# Spokane Design Review Board

### **1. Collaborative Workshop for U-Haul - 1616 Rustle Road**

### Design Review Staff Report

Adams Elementary School Replacement - RECOMMENDATION MEETING APPLICATION

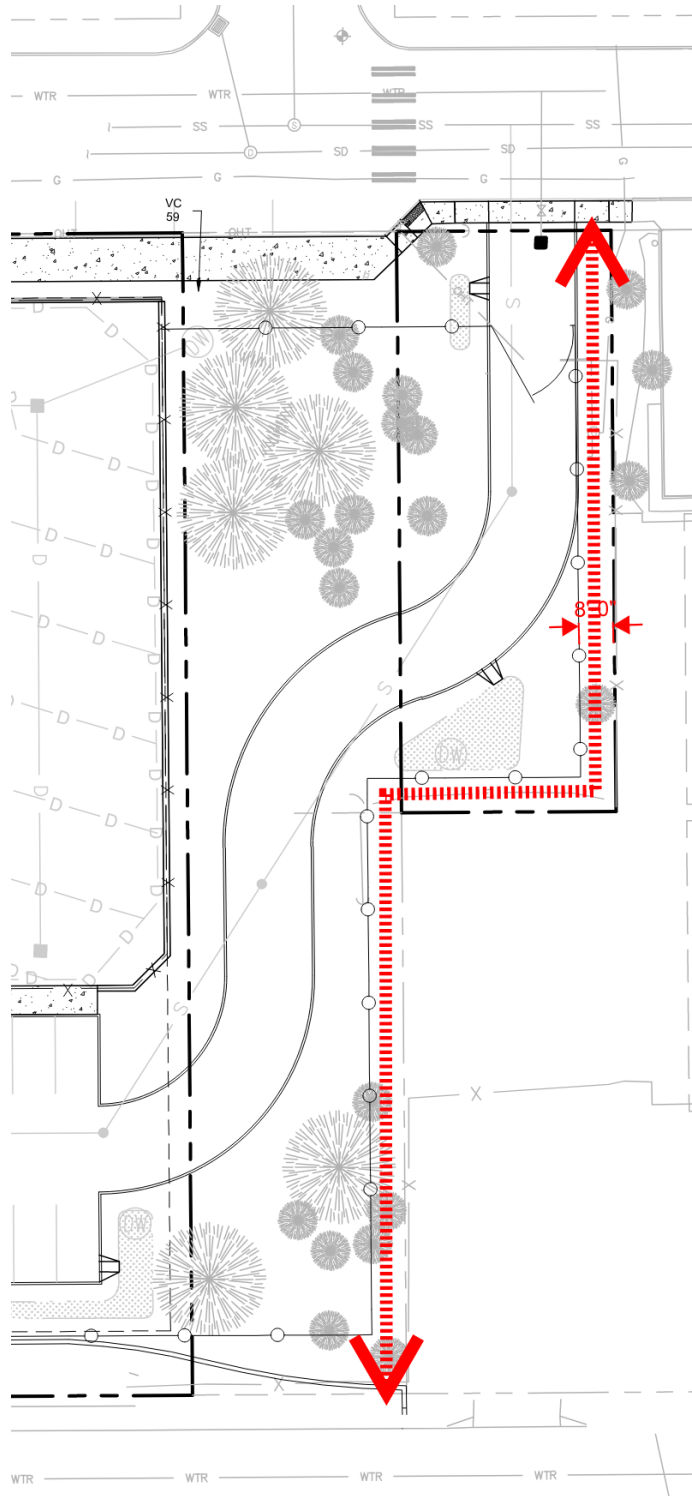
- 5. The Board appreciates the Applicant's intent to soften the grades around the perimeter of the site and provide adequate pedestrian queuing space at Regal St. & 37th Ave.**

Thank you. Yes, the intention is to eliminate as many of the retaining walls as possible and increase the number of plantings and greenery that will enhance the pedestrian experience along the streetscape. New concrete sidewalk has been added to the corner of Regal & 37th to provide expanded pedestrian queuing.

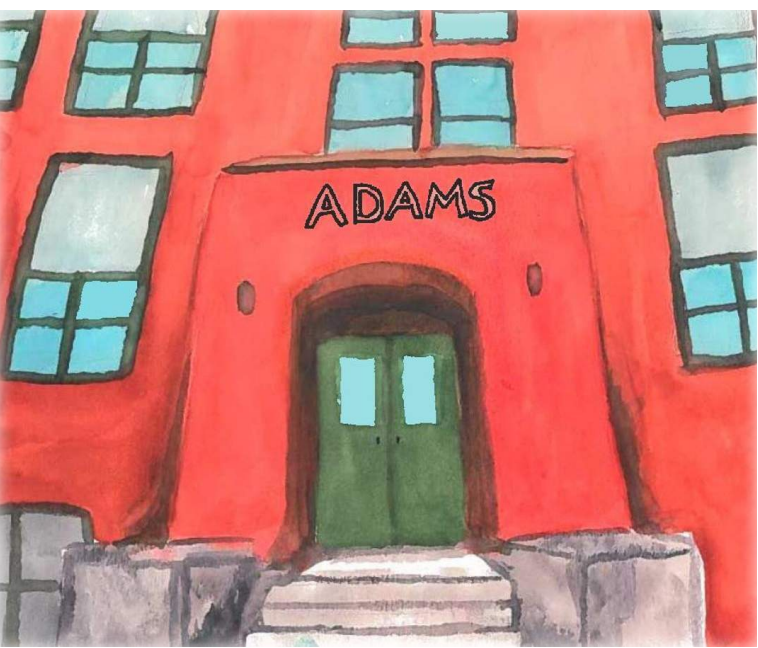
1. The Applicant should continue investigating the opportunity to provide non-motorized access through the site along the vacated Fiske right-of-way (ROW).

In an effort to accommodate a future non-motorized pathway along the vacated Fiske ROW, the perimeter fence on the east side of the site has been re-located in the updated site plan design to allow space for this access.

CONCEPT SITE PLAN

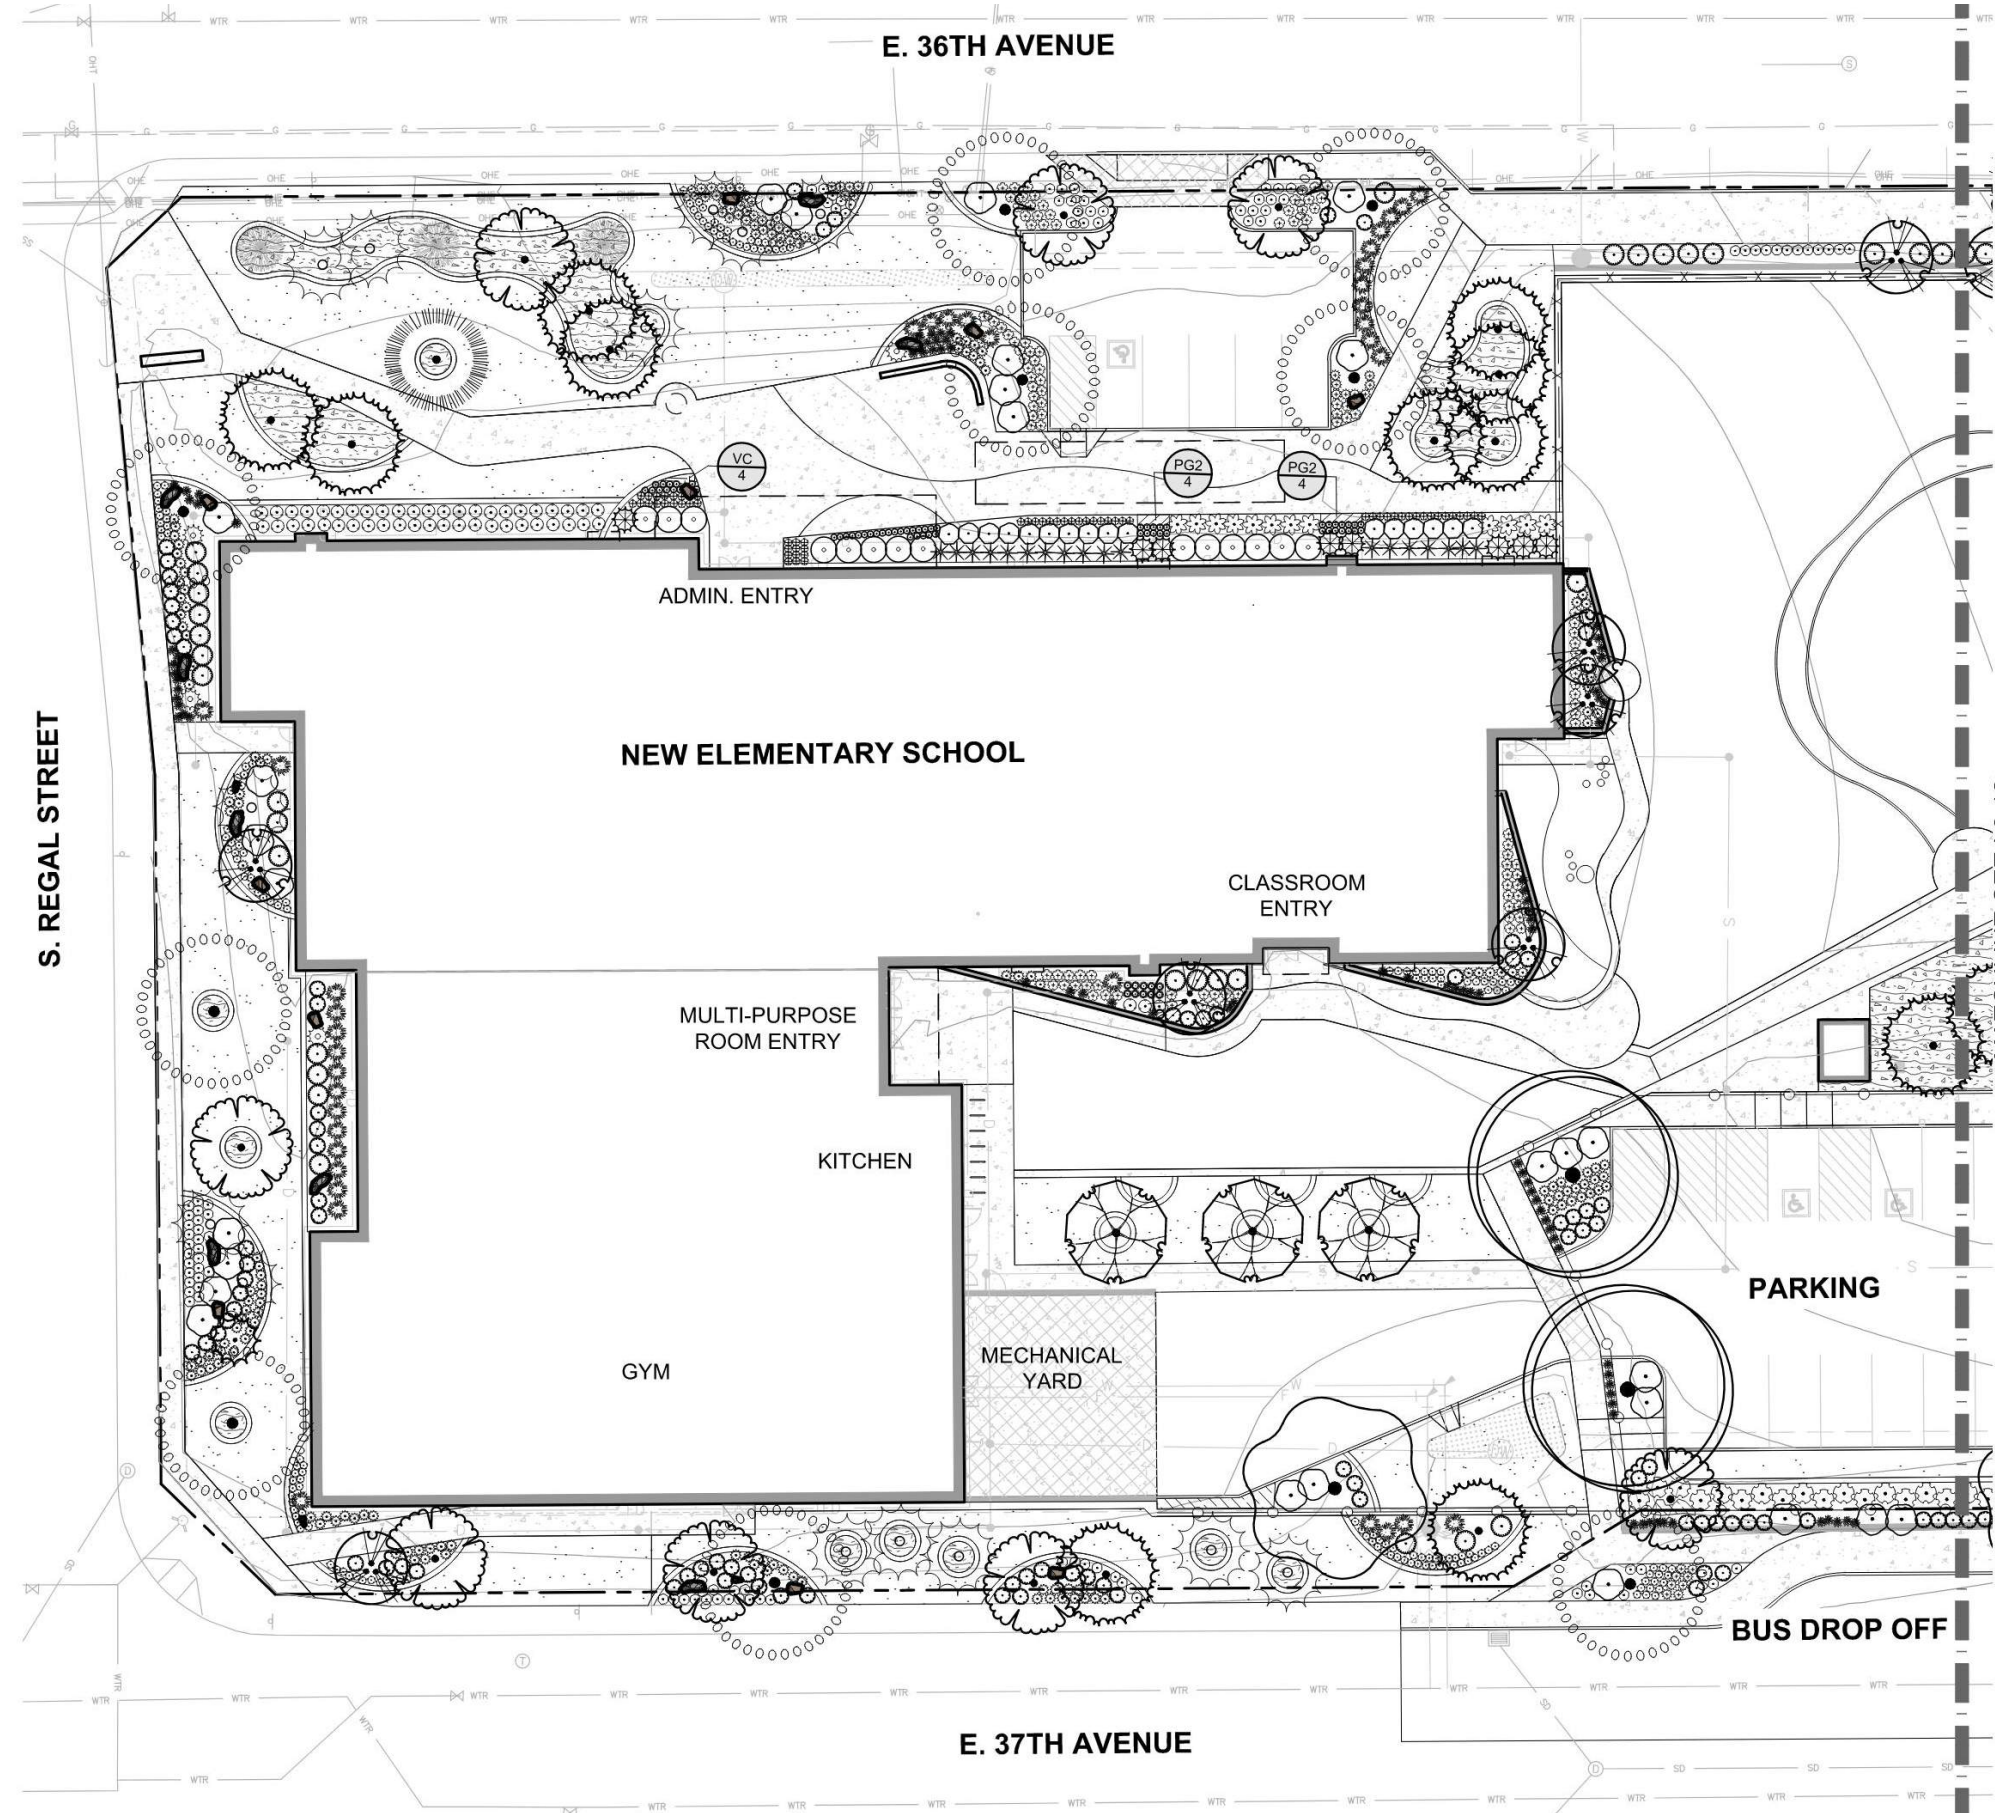
6. The Applicant is strongly encouraged to continue investigating options to soften the vehicle pull-out area on 36th Ave. through landscaping, hardscape material change, or other designs.

Please review the current site plan and planting plan. The vehicle pull-out sidewalk width is generous enough for pedestrians to pass as cars are unloading occupants. The playground fence has been moved south to provide for a landscaping strip between the sidewalk and the fence. Trees have been added where appropriate, especially to highlight the playground entry gate experience. Brick pillars with integral lighting are proposed at the entry gate landing area, as well as seat wall benches for parents to wait for their children under the tree canopy. An ADA compliant access ramp has also been provided for safe travel from the sidewalk to the playground level.
